# RECOMMENDATION MEETING

6015 15th Ave NW Seattle, WA  
3038032-LU RECOMMENDATION MEETING

The site includes multiple existing structures with surface parking that will be demolished. The proposed development is a 5-story residential building with approximately 51 units and 4 tuck-under parking stalls located off the alley.

RECOMMENDATION MEETING - PROPOSED MASSING

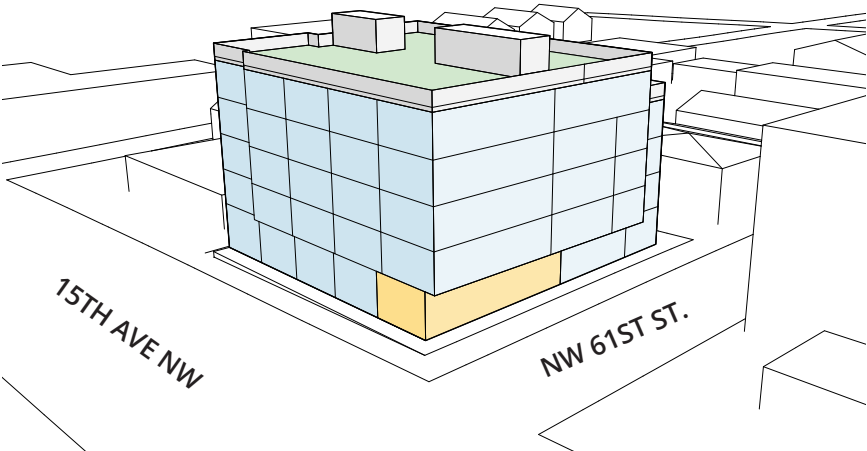
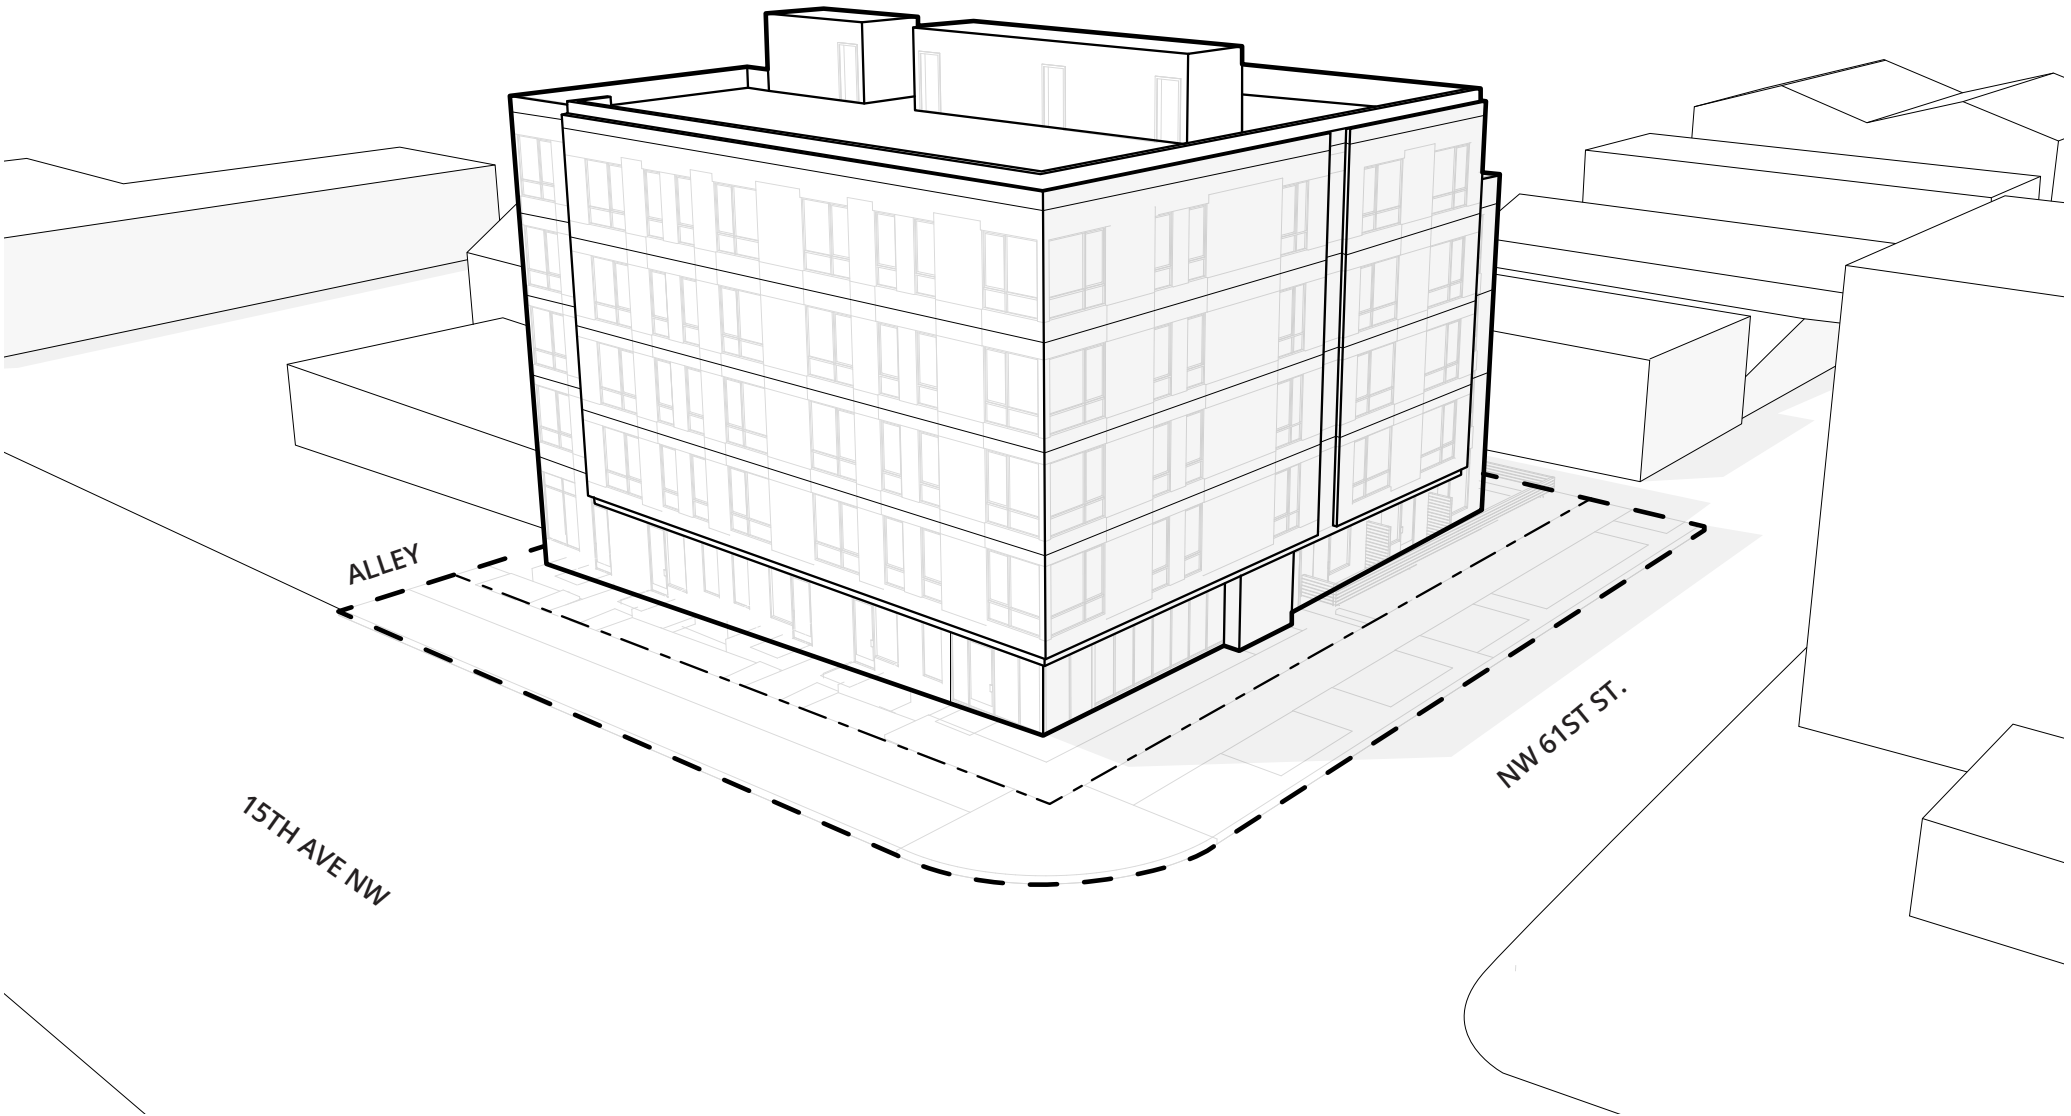
The Board noted that although this site is relatively small, the three massing options presented gave viable alternatives for arranging the building mass to respond to site and program conditions. The Board unanimously supported Option C, the preferred option. The Board specifically supported the upper level overhang in Option C that emphasizes the corner location that is balanced by a recess at the ground level that creates space to develop the streetscape. They supported the shift of massing at the upper level towards the busy 15th Ave NW arterial and away from the zone transition to LR1.

The Recommendation Meeting massing is consistent with EDG Option C.

RECOMMENDATION MEETING - MAIN CORNER ENTRY

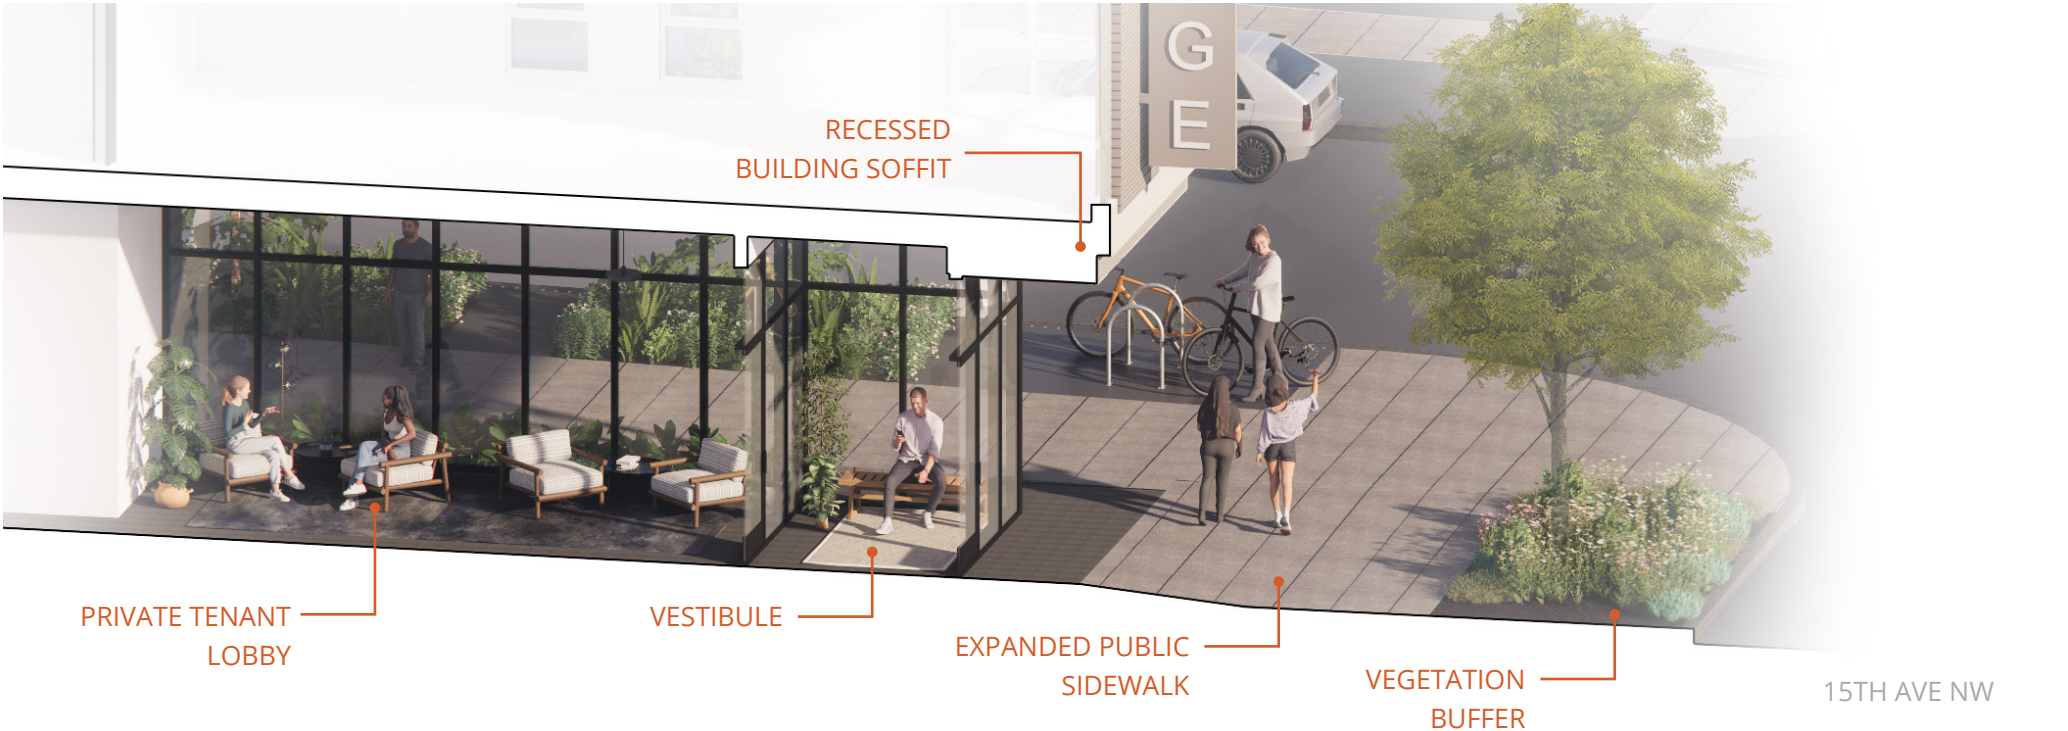
The Board requested that the height of the overhang at the corner be assessed to avoid a visual pinch point of the massing at the main residential entry lobby.

The Board requested further study of the location of the main residential entry door within the corner lobby location indicated in Option C at the Recommendation phase. They noted that clear way finding and identification of the entry was important for building function.

10' tall floor to ceiling glazing wrapping the corner emphasizes the openness and vertical clearance at the building entry.

The main building entrance has been relocated to face 15th Ave NW, paired with signage for clear way finding and entry direction.

RECOMMENDATION MEETING - EAST ELEVATION AT STREET LEVEL (15TH AVE NW)

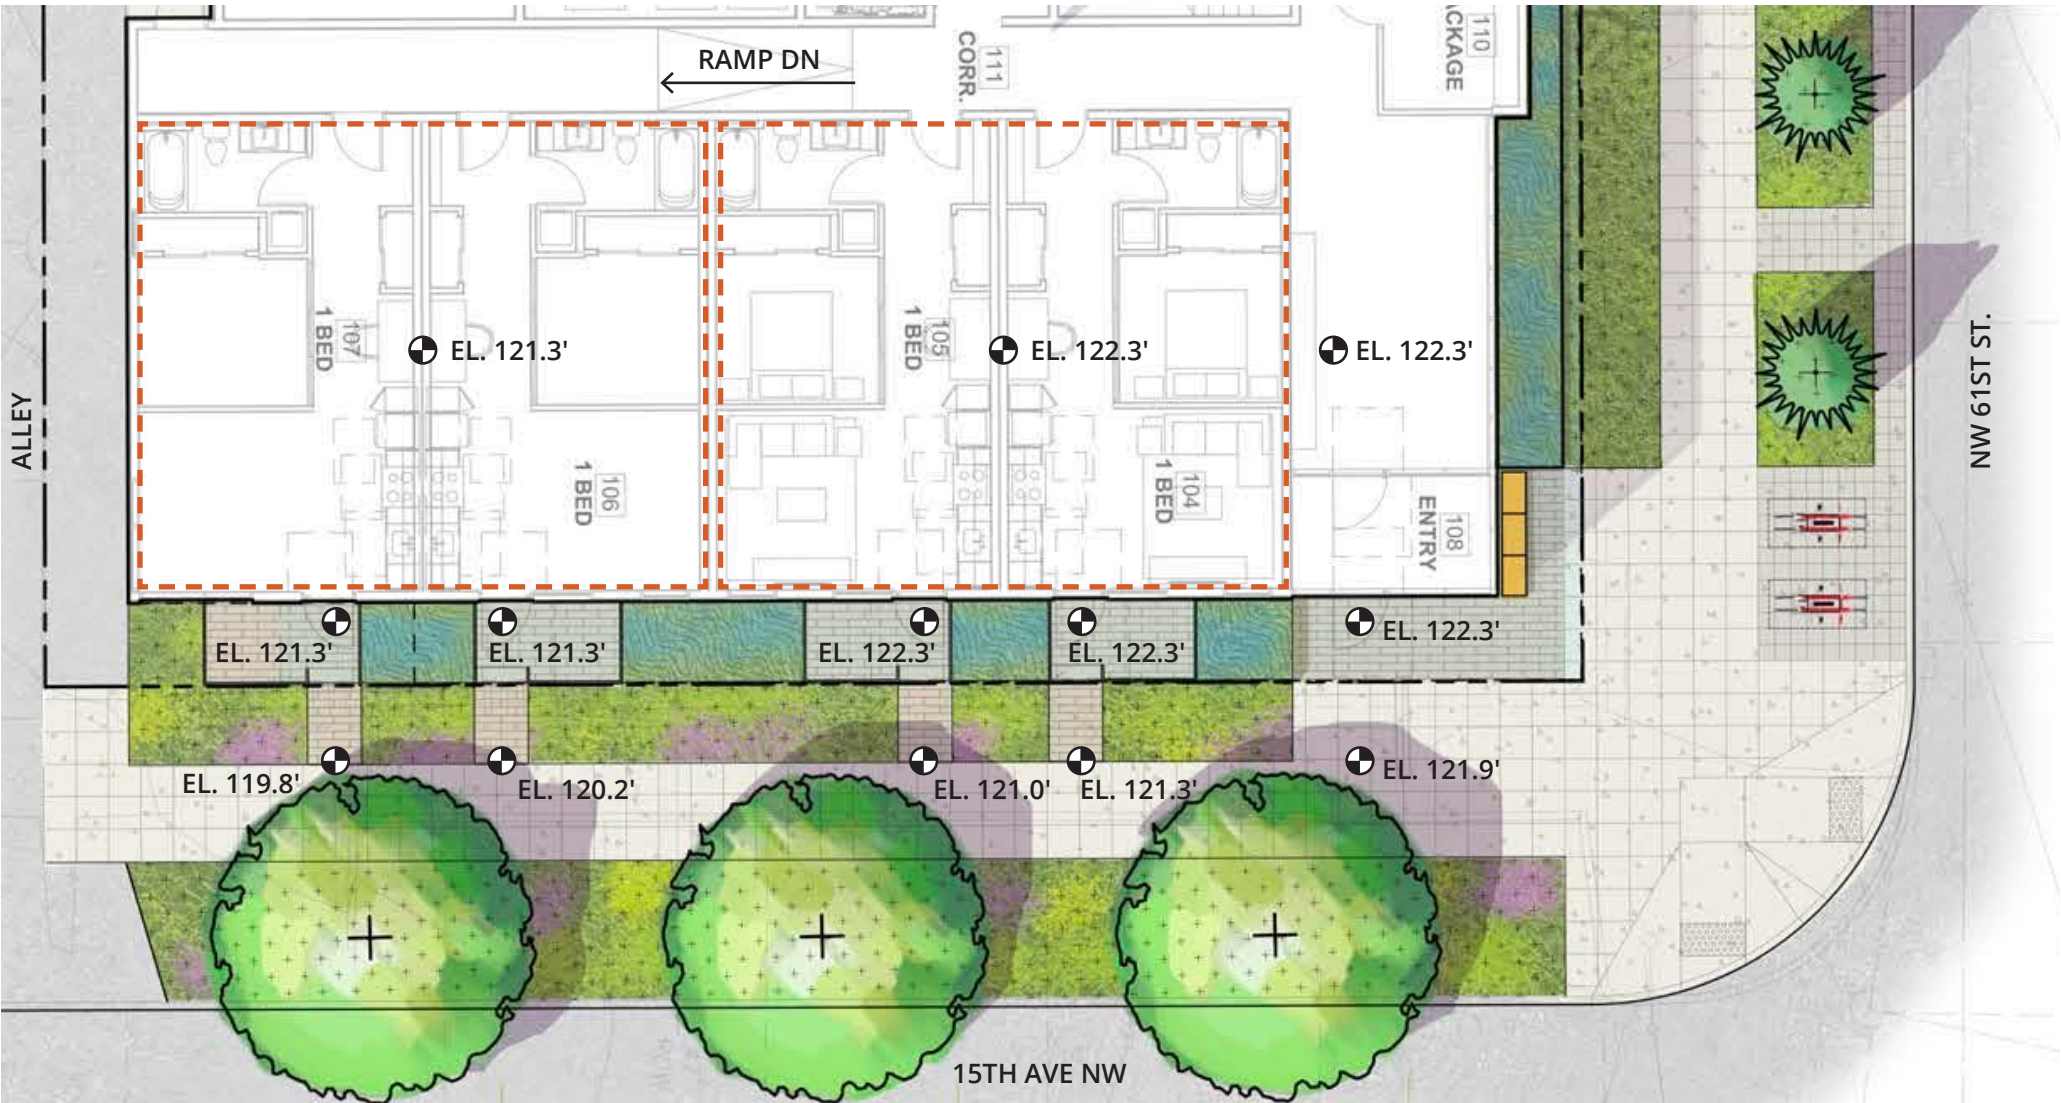
The Board asked about the level of the live-work units relative to the sidewalk. The applicant noted that, as there is no basement in the building, there is some flexibility in setting those finish floor elevations. The Board requested a study of how the level of how the ground level units are set to allow accessibility from the street.

The Board asked about overhead weather protection, especially in relation to the live - work unit entrances. The applicant noted that the overhang at the northeast corner would provide integrated weather protection for several of the entries. The Board requested further exploration of weather protection at all of the live -work entries at the Recommendation phase

The Board supported the 5 foot ground level setback along both street frontages, as shown in Option C, that creates space for a transitional zone between the public sidewalk and the semi-private live-work units. The Board specifically requested information on the further development of the landscape buffer at the Recommendation phase. They noted this area should be developed to serve as a transitional space to the live-work unit entries as well as an integral part of the streetscape development.

Floor finish at the ground floor units step down with the grades along 15th Ave NW to provide individual stoops at each entry.

The 5' overhang along the East and North facades provides weather protection. The unit entries that are not located under the overhang have individual canopies.

The 5' ground level setback has been developed with individual unit stoops along 15th Ave NW with bio-retention planters in between. Units along 61st have private outdoor patios to transition to the LR zone.

RECOMMENDATION MEETING - EAST ELEVATION AT STREET LEVEL

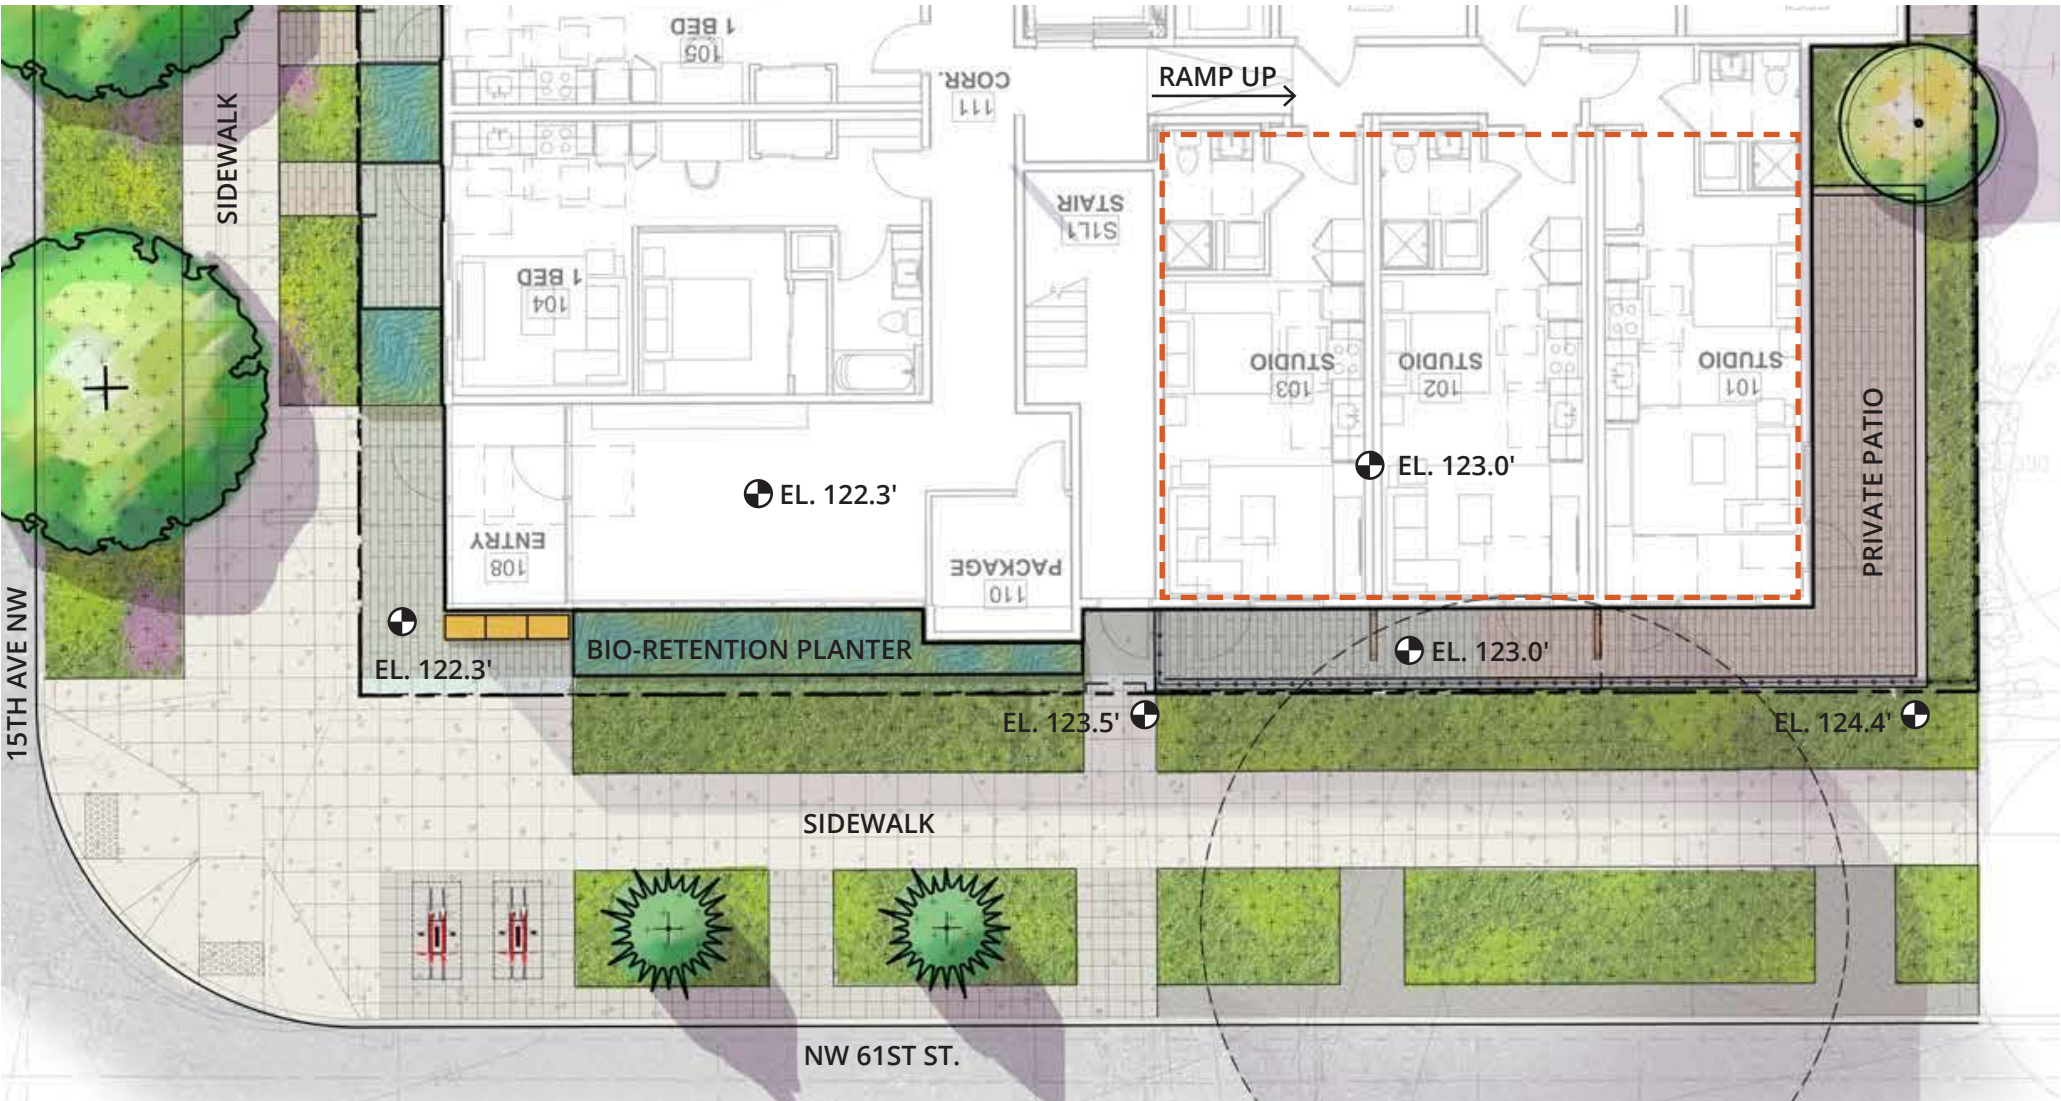
The Board asked about the level of the live-work units relative to the sidewalk. The applicant noted that, as there is no basement in the building, there is some flexibility in setting those finish floor elevations. The Board requested a study of how the level of how the ground level units are set to allow accessibility from the street.

The Board asked about overhead weather protection, especially in relation to the live - work unit entrances. The applicant noted that the overhang at the northeast corner would provide integrated weather protection for several of the entries. The Board requested further exploration of weather protection at all of the unit entries at the Recommendation phase

The Board supported the 5 foot ground level setback along both street frontages, that creates space for a transitional zone between the public sidewalk and the dwelling units. The Board specifically requested information on the further development of the landscape buffer at the Recommendation phase. They noted this area should be developed to serve as a transitional space to the unit entries as well as an integral part of the street-scape development.

**The ground floor units facing NW 61st Street have private individual patio access from the inside. Direct access to the sidewalk was removed to create privacy and a residential scale next to the LR zone.**

**The 5' overhang along the East and North facades provides weather protection. The unit entries that are not located under the overhang have individual canopies.**

**The 5' ground level setback has been developed with individual unit stoops along 15th Ave NW with bio-retention planters in between, and a landscape buffer between the sidewalk and property line.**
